**SUBJECT: COMANCHE PEAK NUCLEAR POWER PLANT, UNITS 3 AND 4
DOCKET NUMBERS 52-034 AND 52-035
RESPONSES TO REQUESTS FOR ADDITIONAL INFORMATION NO. 2747 AND 3214**

Response to Request for Additional Information No. 2747 (CP RAI #29)

Response to Request for Additional Information No. 3214 (CP RAI #28)

Figure 11.2-201 Liquid Waste Management System Piping and Instrumentation Diagram (Sheet 9 of 10)

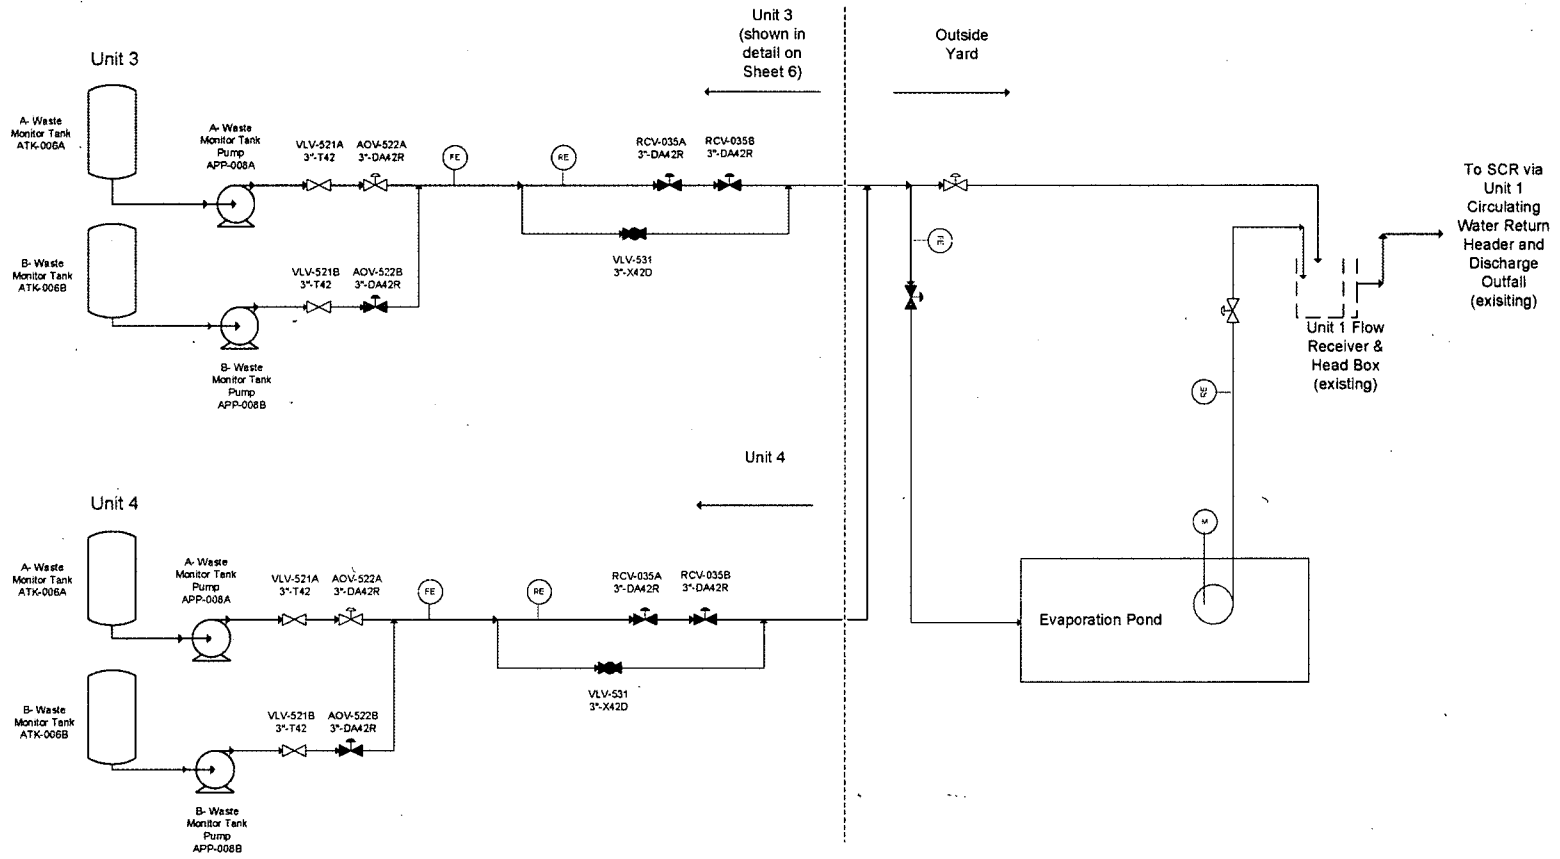
- (1) Describe in the FSAR how the effluent holdup (evaporation) pond will meet the guidance of SRP Section 11.2, "Liquid Waste Management System," and RG 1.143, "Design Guidance for Radioactive Waste Management Systems, Structures, and Components Installed in Light-Water-Cooled Nuclear Power Plants," Revision 2, November 2001, or justify an alternative.

- (3) Discuss provisions for sampling of the effluent holdup pond or justify why these provisions are not discussed.
- (4) Clarify how the requirements of 10 CFR 20.1406, "Minimization of Contamination," are met.

- (2) A radiation monitor has been added to the discharge line downstream of the evaporation pond. The radiation monitor is set to alarm in the unlikely event that the effluent exceeds the radiation setpoint (the same setpoint as the waste monitor tank discharge). The radiation monitor alarms in the Radwaste Control Room and the Main Control Room for operator action. The signal will also simultaneously turn off the evaporation pond discharge pump and close the discharge valve. Figure 11.2-201 (Sheet 9 of 10) has been revised to reflect the response above.

Figure 19.1-2R Simplified System Diagram (Sheet 18 of 36) (Essential Service Water System [2of2])

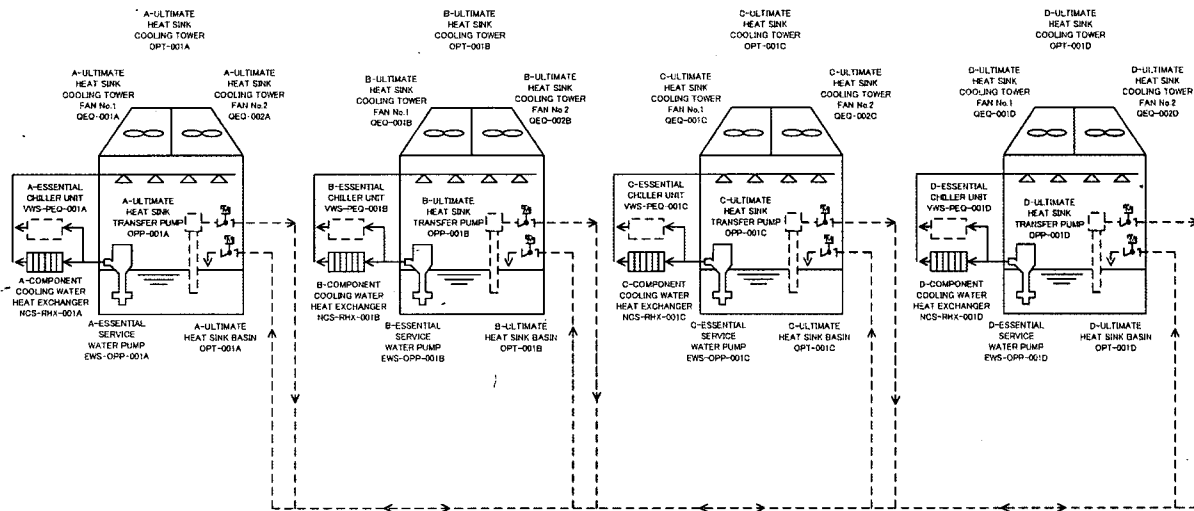
The site-specific essential service water system (ESWS)/ultimate heat sink (UHS) used at Comanche Peak Units 3&4 introduces many changes in the risk insights and assumptions identified at the design certification Design Control Document (DCD). Even though the numerical impact of the change on the estimated CDF is small, there are important changes in the risk insights and assumptions as a result of the site-specific ESWS/UHS change. Therefore, the Comanche Peak FSAR should include changes to all impacted areas (sections) of the incorporated by reference US-APWR DCD. Examples are: (1) DCD tables, such as Tables 19.1-27 to 19.1-34, include failures of components and human actions that are not part of the site-specific design (e.g., failure to cool the ESWS pumps) and leave out risk important components and human actions that are part of the site-specific design (e.g., failure of the cooling tower fans); (2) DCD table 19.1-115 listing key assumptions and important design features; and (3) results of the PRA-based seismic margins analysis (e.g., HCLPF values of the cooling towers and related structures and any changes in the major seismic contributors identified in the DCD). Please perform a systematic search to identify all sections of the incorporated by reference DCD, including both internal and external events at power and shutdown modes of operation, that are impacted by the site-specific ESWS/UHS, update all such sections and clearly describe the changes in Chapter 19 of the Comanche Peak FSAR.

- Key site-specific design features, PRA insights and assumptions need to be described in the FSAR. Treatment of site-specific design features and key assumptions is described in Part (2) of this response.
- Figure 19.1-2R has been added to the FSAR to provide site-specific details.

Figure 19.1-2R, page 19.1-40 has been added to describe the site-specific UHS.
